## PRODUCT/PROCESS CHANGE NOTICE (PCN)

<b>PCN #:</b> TB-0510-02 <b>DATE:</b> 29-Nov-2005 <b>Product Affected:</b> 48L Cerpack & 84L Flatpack (Refer to Attachment II for affected parts)  <b>Date Effective:</b> 29-Dec-2005	<b>MEANS OF DISTINGUISHING CHANGED DEVICES:</b> <input type="checkbox"/> Product Mark <input type="checkbox"/> Back Mark <input type="checkbox"/> Date Code <input checked="" type="checkbox"/> Other      Change in carrier color
---	--

### ATTACHMENT I - PCN #: TB-0510-02

#### 48L Cerpack Carrier

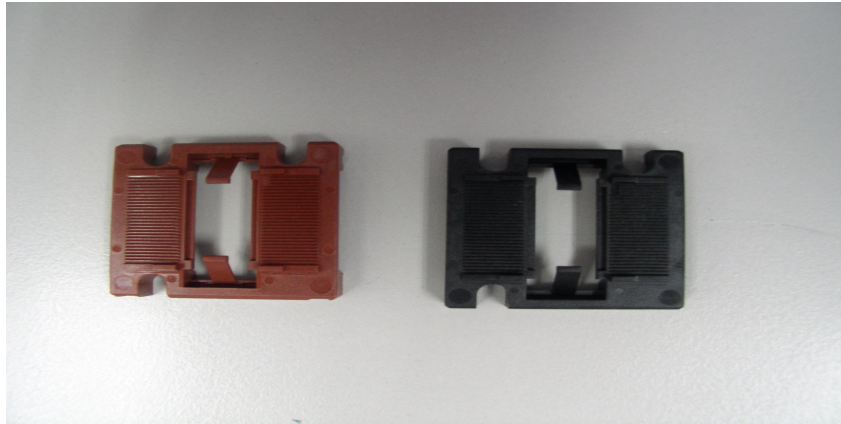
**Detail of Change:** There is no change in dimension for new carriers except for the color of carriers. For 48L Cerpack, carrier will be changed from red color to black color. For 84L Flatpack, carrier including carrier clip will be changed from green color to black color.
